PARK CITY PLANNING COMMISSION MEETING
SUMMIT COUNTY, UTAH
March 24, 2021

5.A. 9300 Marsac Ave (Sommet Blanc/B2East Parcel) – Applicant is Requesting a Work Session Before the Planning Commission Prior to Public Hearings for a Conditional Use Permit and Amendments to the Approved Master Planned Development and Flagstaff Development Agreement for Proposed Development of 43 Residential Units Above Underground Parking, and 5 Condominium Villas on the North-eastern Portion of the Site on the B2East Parcel. PL-20-04702.

6.D. Park City Mountain Resort Base Parking Lots - MPD Modification - Replace Expired Exhibit D of the DA, the 1998 PCMR Base Area Master Plan Study Concept Master Plan, With a New Master Plan, Known as the Park City Base Area Lot Redevelopment Master Plan Study. This Hearing Will Focus On the Applicant's Proposed Circulation and Transportation Plans, Scenario 2b, in Accordance with the MPD, and Applicable LMC, General Plan and Transportation Master Plan Criteria. PL-20-04475.
Public Input will be taken via e-comments

Exhibit A2: Bus Stop and Shuttle Drop-Off

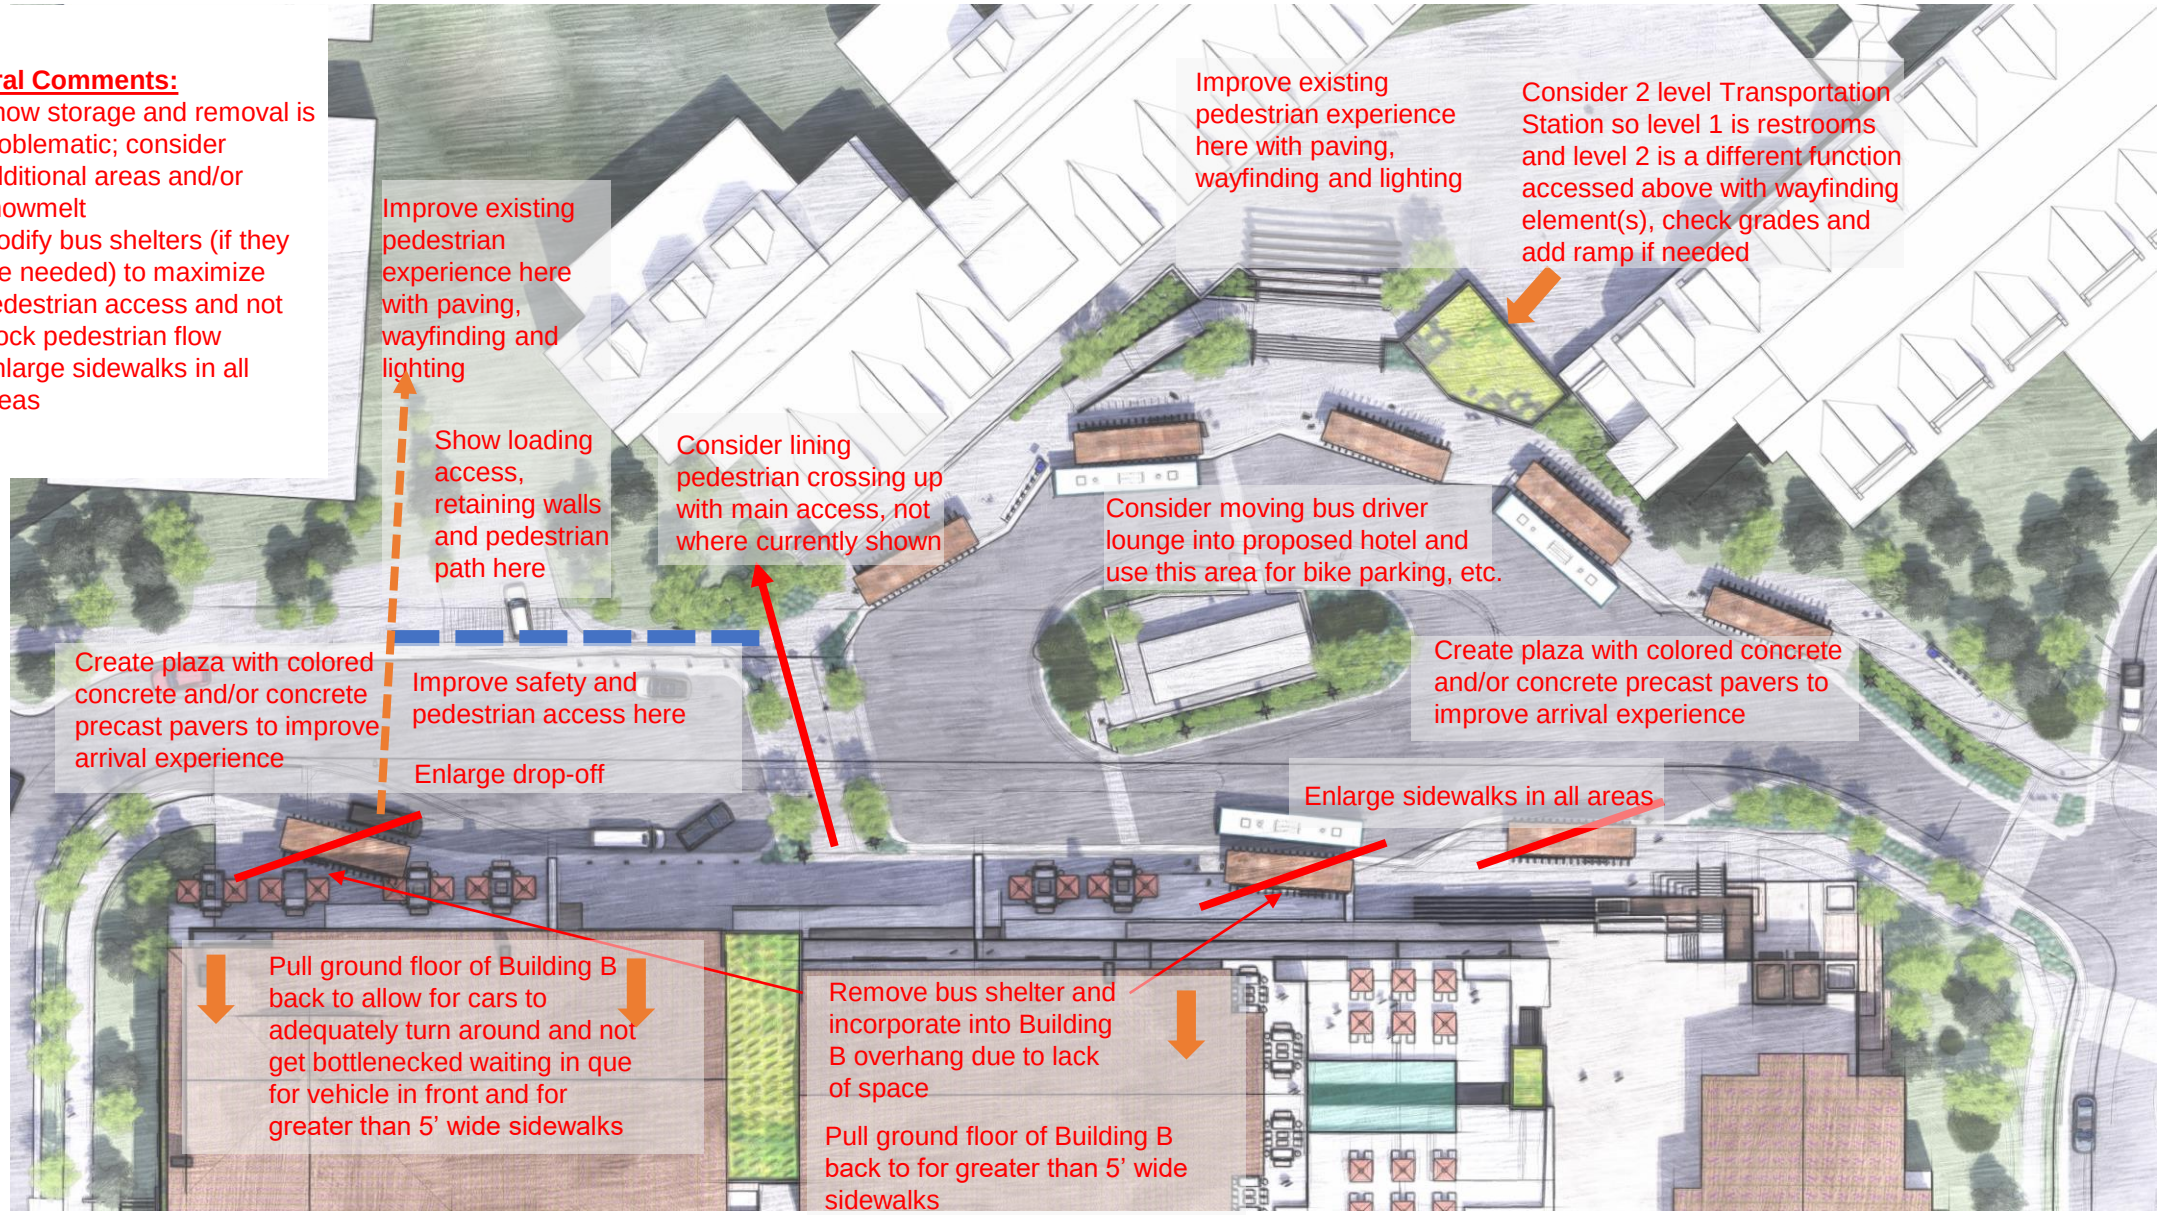
1. Snow storage and removal is problematic; consider additional areas and/or snowmelt
2. Modify bus shelters (if they are needed) to maximize pedestrian access and not block pedestrian flow
3. Enlarge sidewalks in all areas

AECOM Comments, 3/16/21
Exhibit A3: Shuttle Drop-off

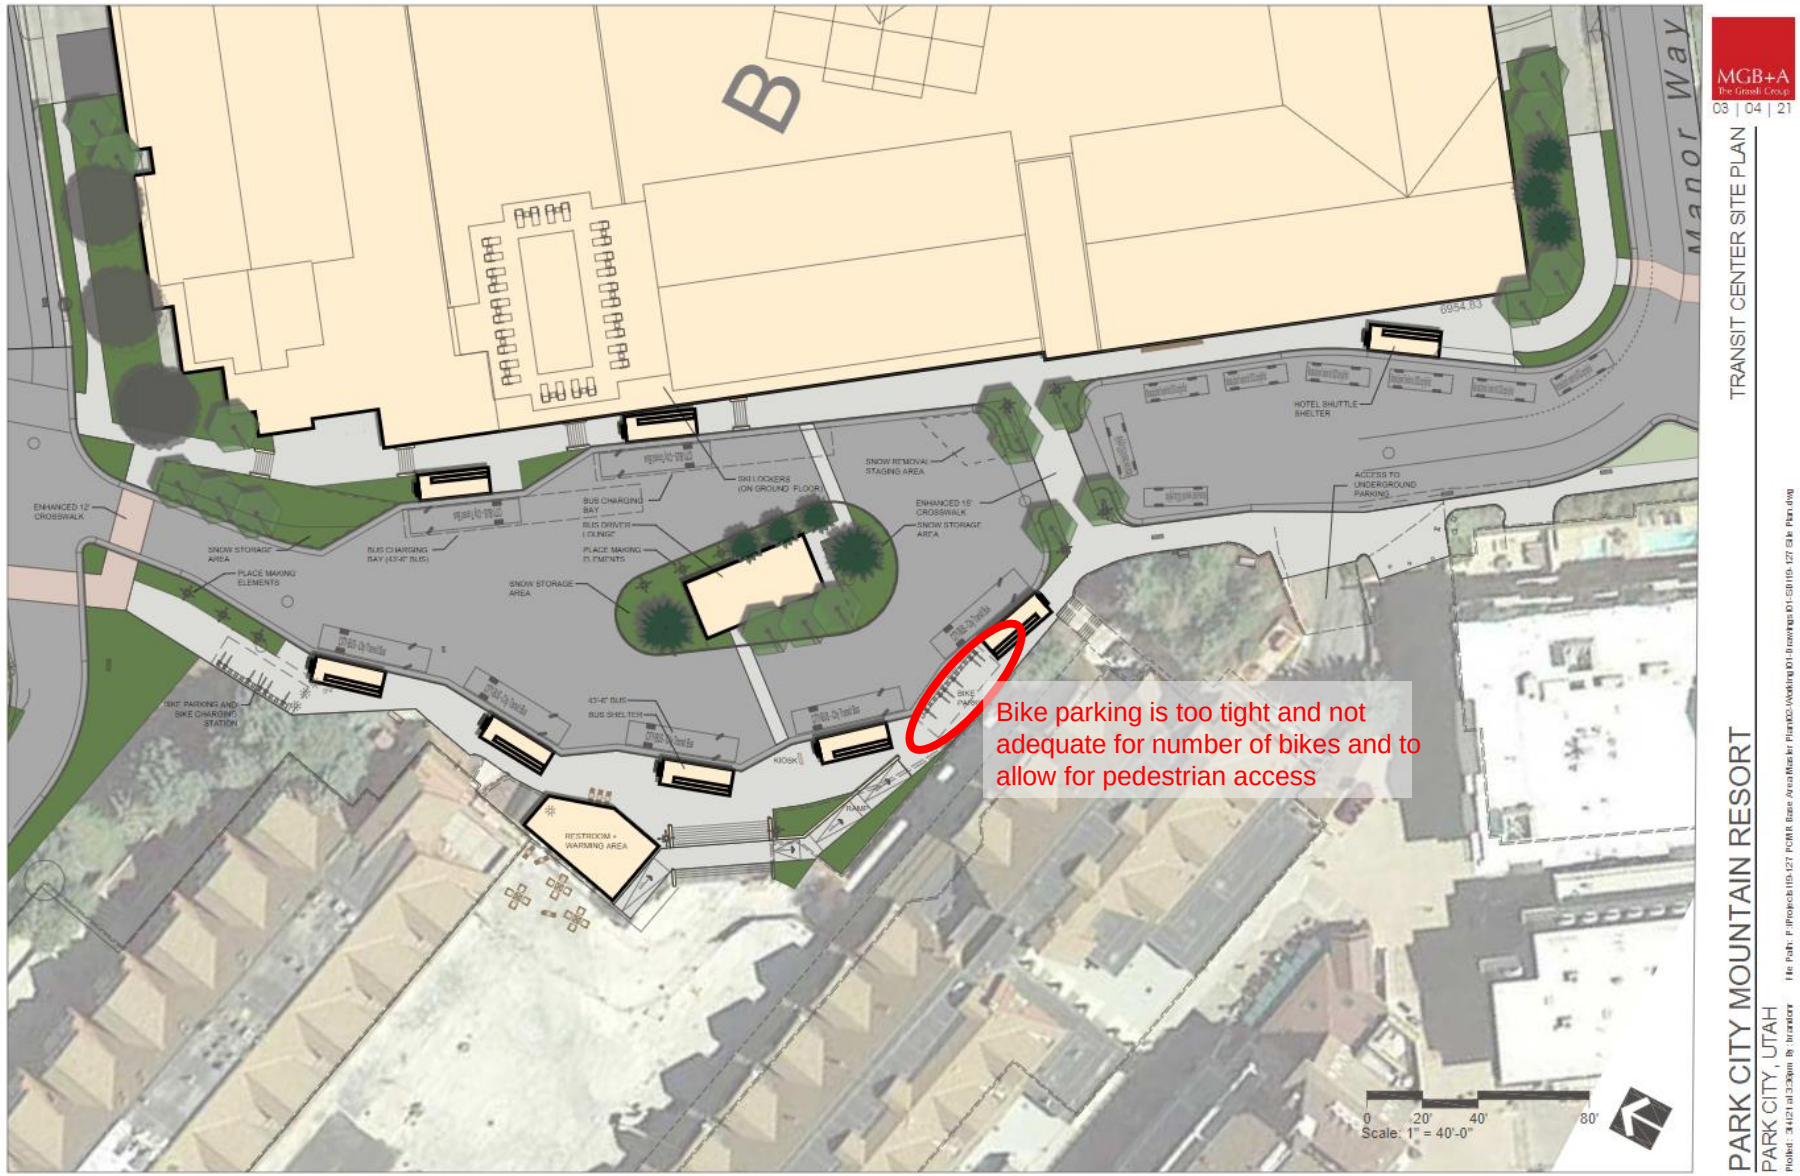
1. Snow storage and removal is problematic; consider additional areas and/or snowmelt
2. Label where all garage access, loading/drop-off areas and back-of-house areas are located to identify pedestrian conflicts; revise and mitigate pedestrian conflicts
3. Address mountain biking access from parking to trails

AECOM Comments, 3/16/21
Exhibit B2: Pedestrian Plaza Area

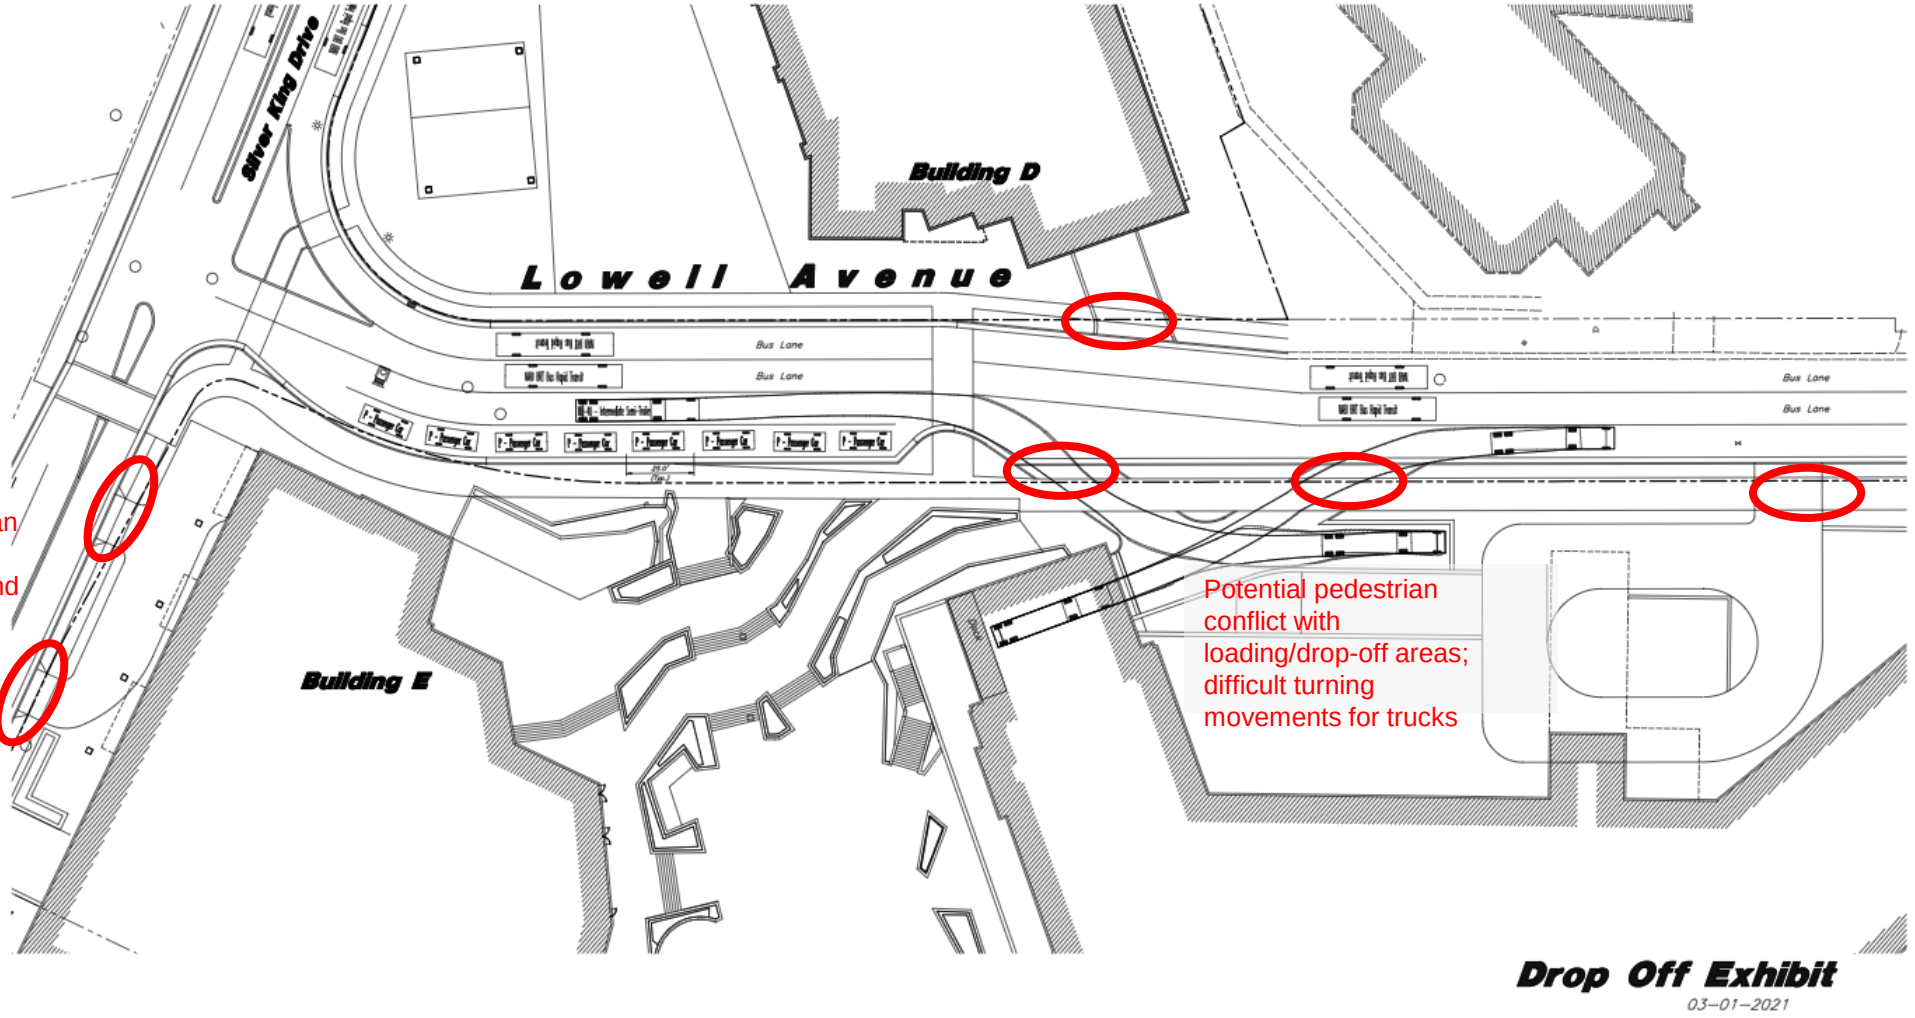
Potential pedestrian conflict with loading/drop-off and access areas

Potential pedestrian conflict with loading/drop-off areas; difficult turning movements for trucks

Figure 3

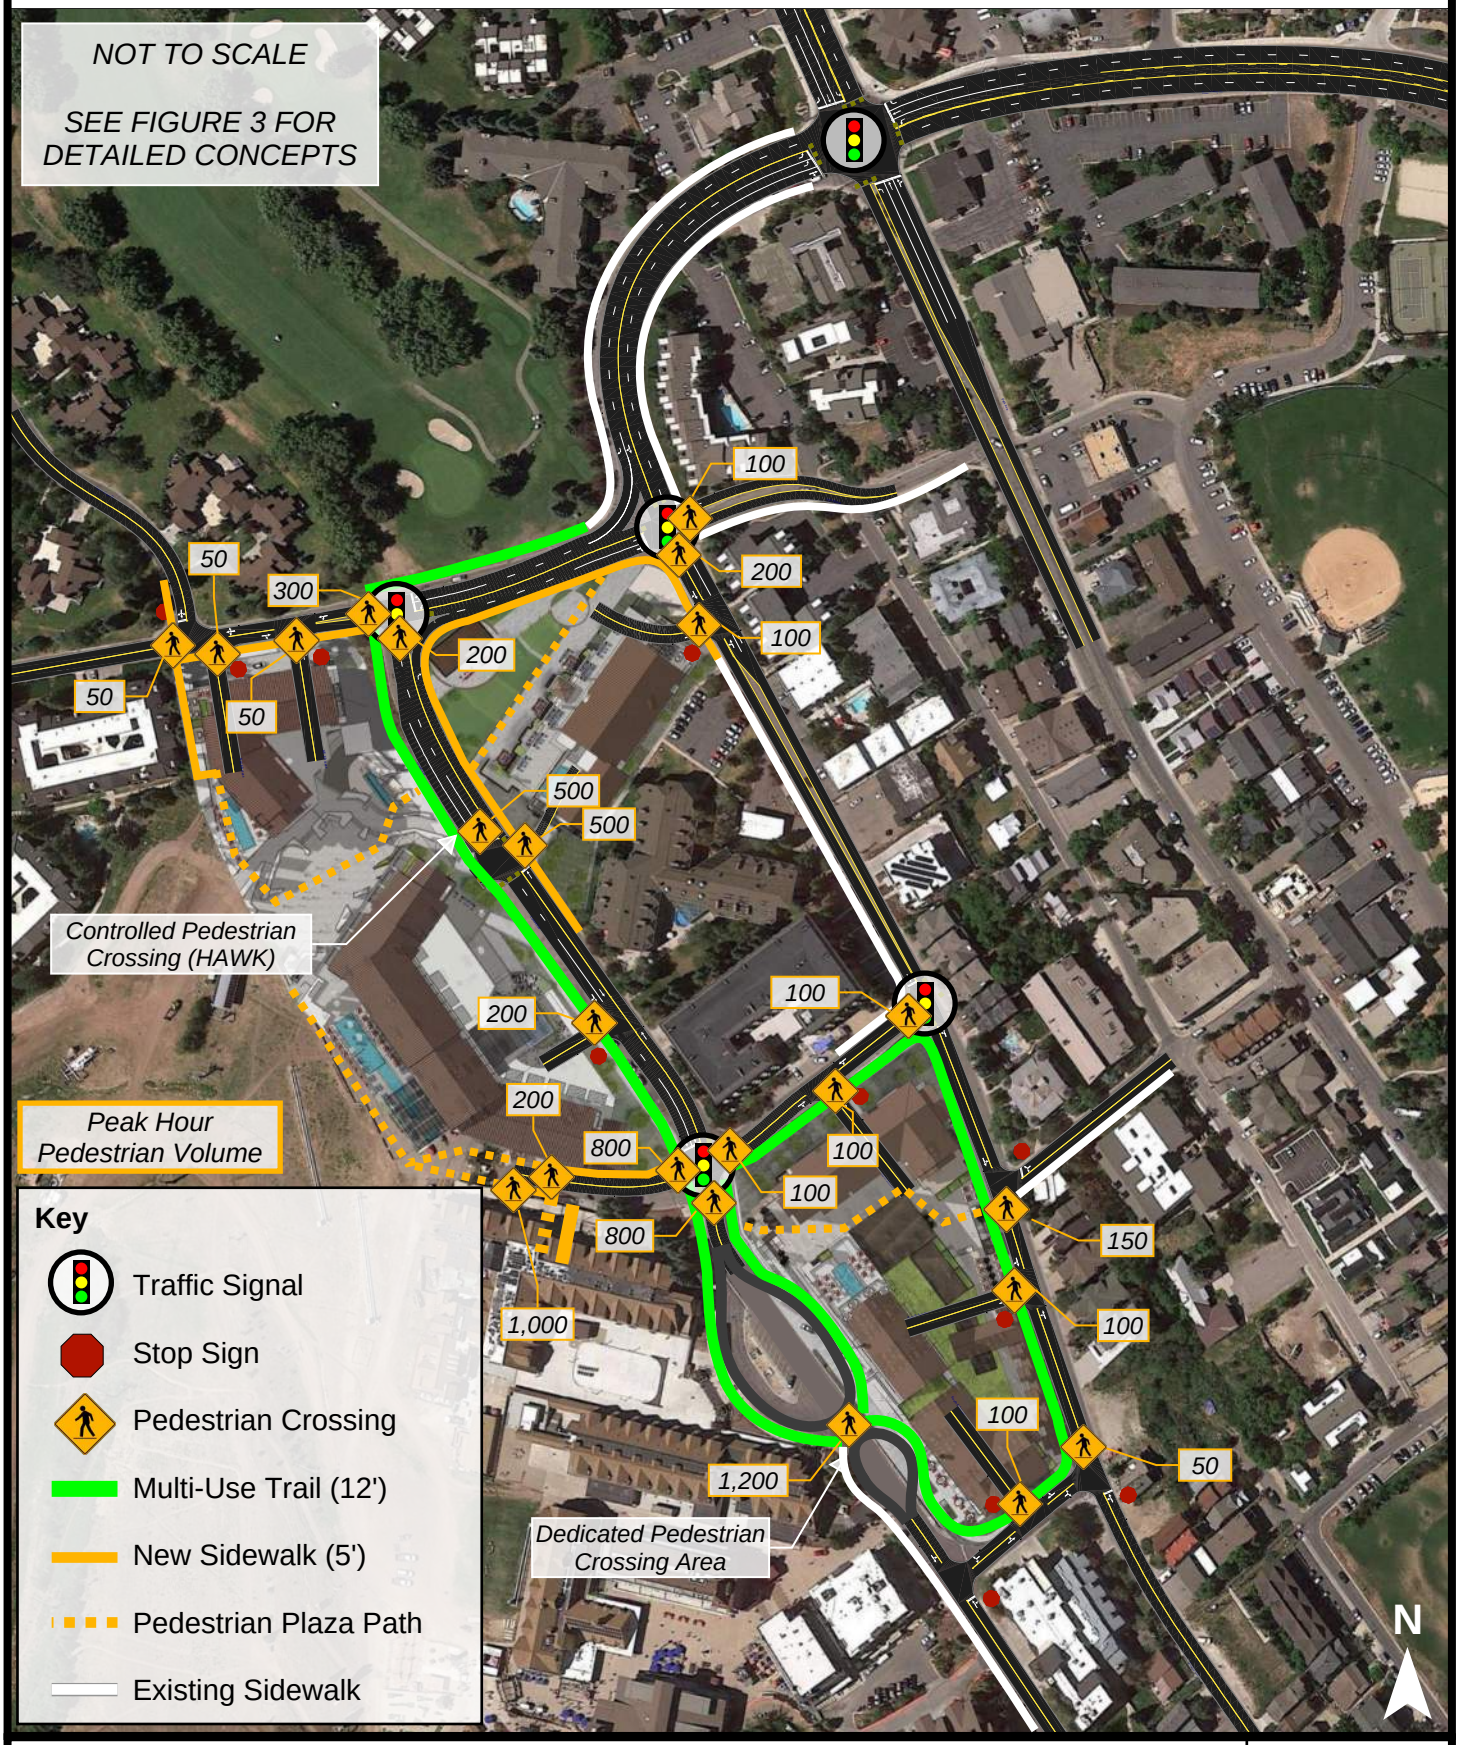
6. Five foot wide sidewalks are not sufficient to accommodate the volume of pedestrians as shown in Figure 3 on various portions of the site. Figure 3 shows 800 pedestrians an hour during peak times; how can the applicant possibly believe this is a sufficient width? The CMP called for 15 foot wide sidewalks.
